Tim O'Neil Baseball Field Improvements

Addenda # 1

March 1, 2019

2 SAWCUT AND REPAIR
NOT TO SCALE

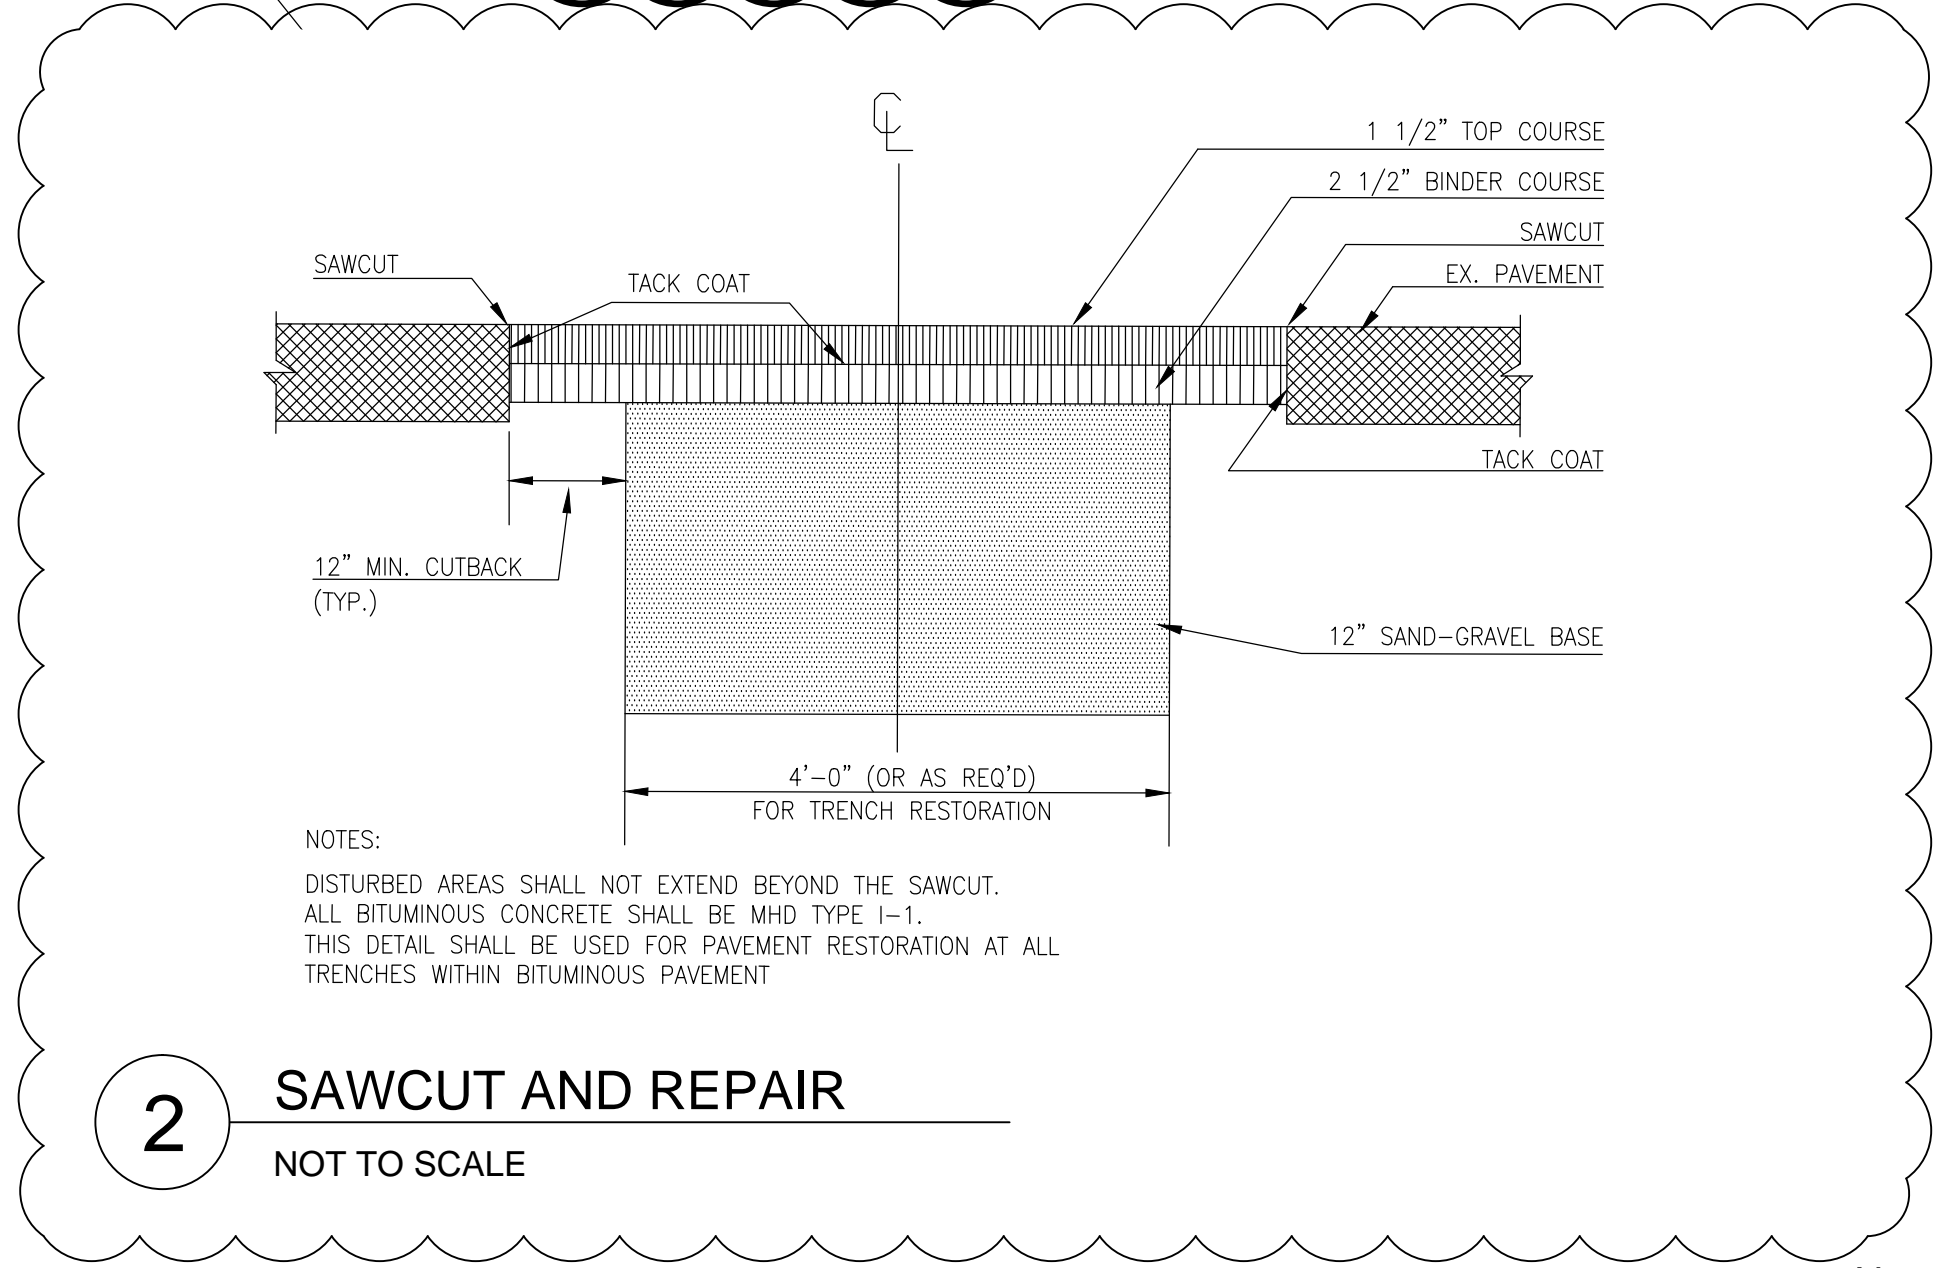
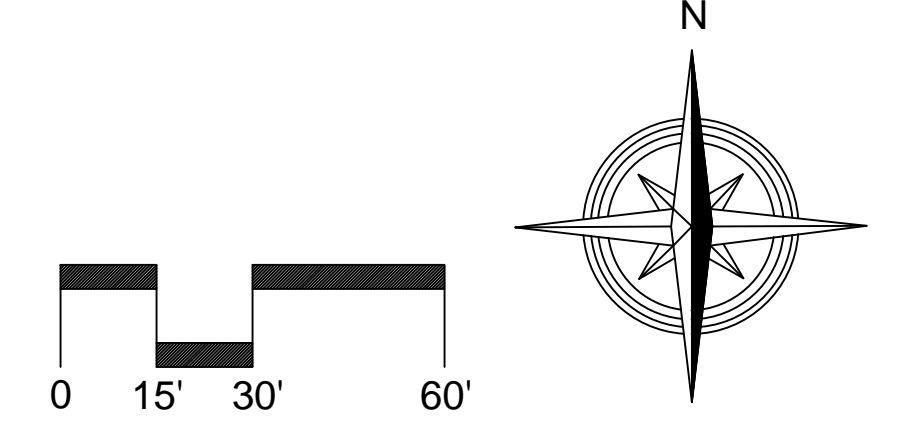
- 1. Sheet L-2 Site Construction: Additional notations and detail**
- 2. Sheet L-4 Construction Details: Additional detail**

Does contract include asphalt trenching and repair for new electrical line?

Yes, bituminous concrete walkway should be sawcut, trenched, and replaced in kind from electric source to end of walkway.

ELECTRIC TO SCOREBOARD, THROUGH 1" PVC PIPE IN 18" DEEP TRENCH ALONG FENCELINE FROM SOURCE. CONFIRM EXISTING ELECTRIC LOCATION IN FIELD. SAWCUT, TRENCH, AND REPAIR IN KIND.

4 BULLPEN PITCHER'S MOUND
L-2 1/4" = 1'-0"

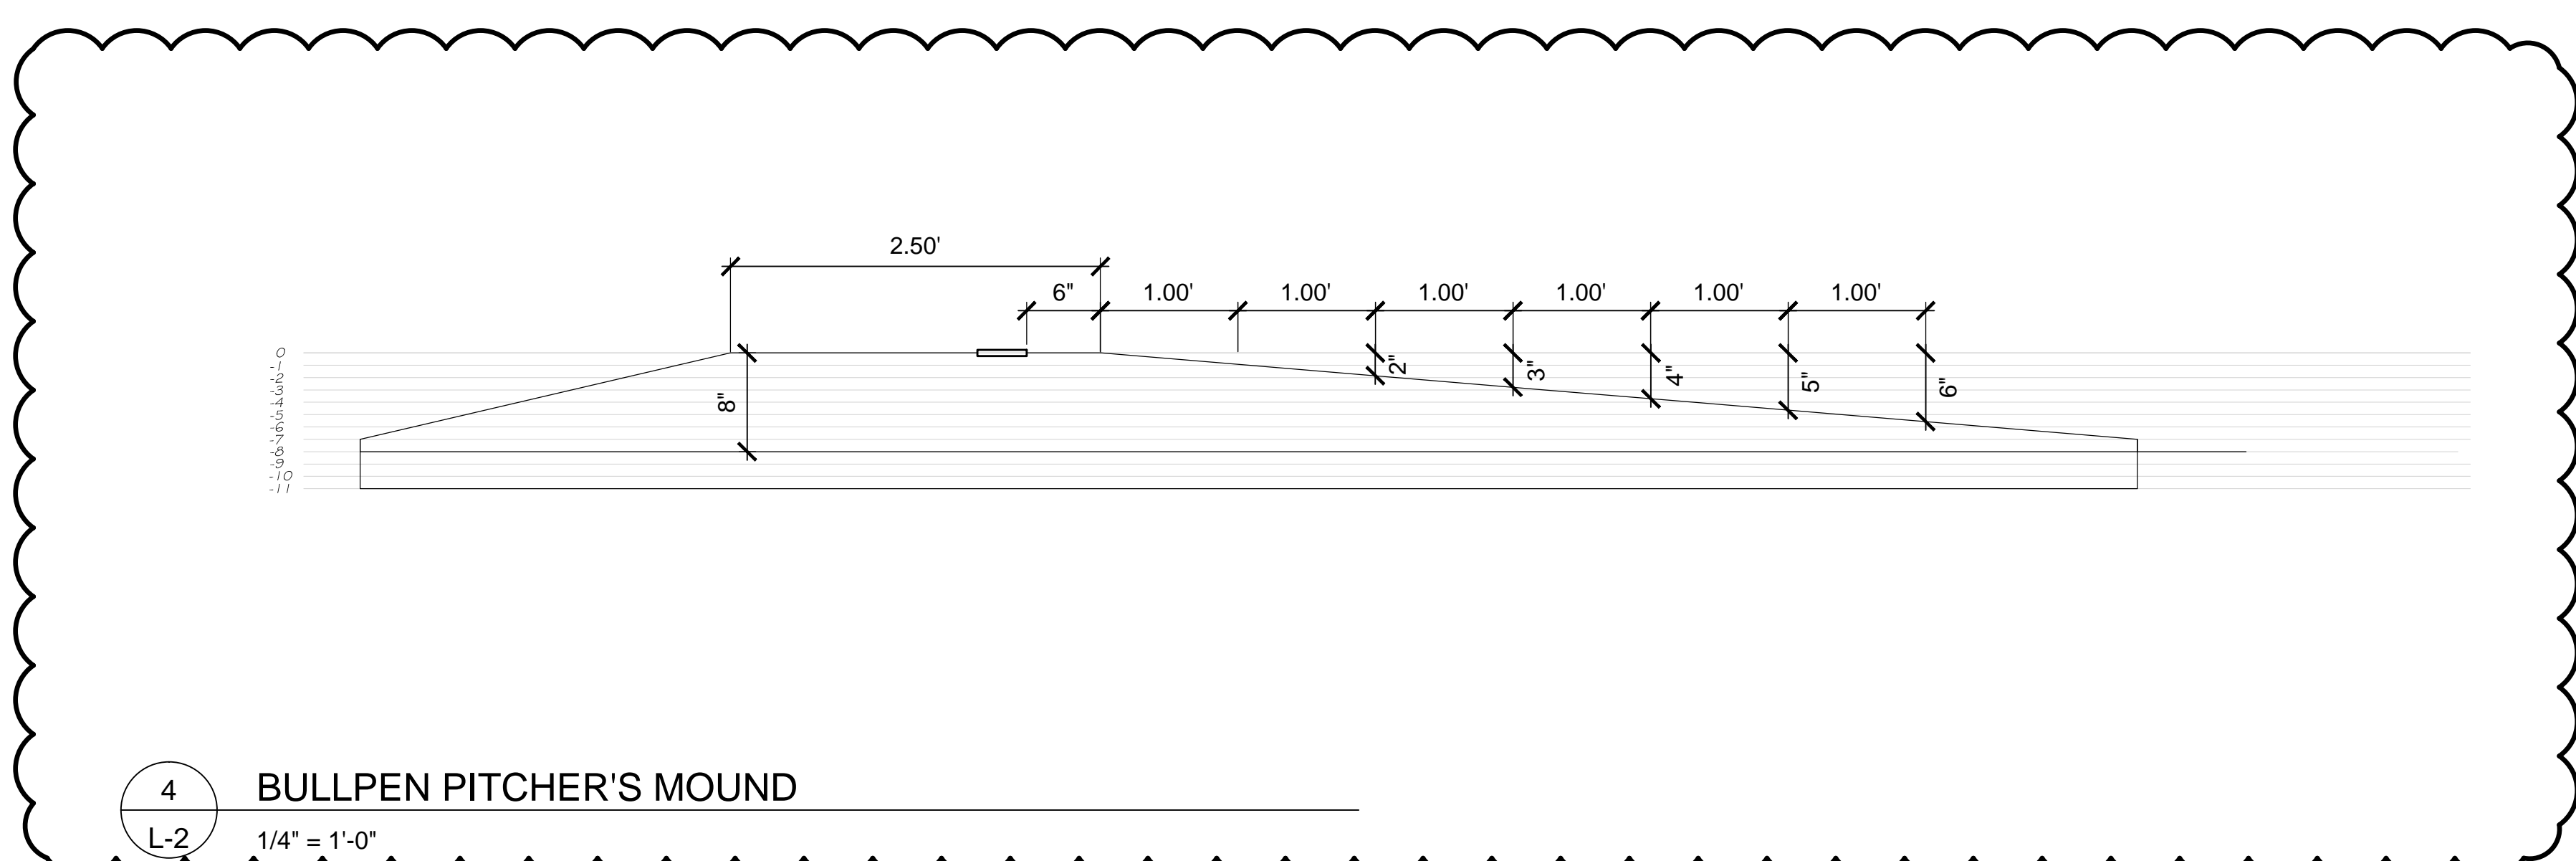
Does the new bullpen include a pitcher's mound?

Yes, the new bullpen is to include a pitcher's mound.
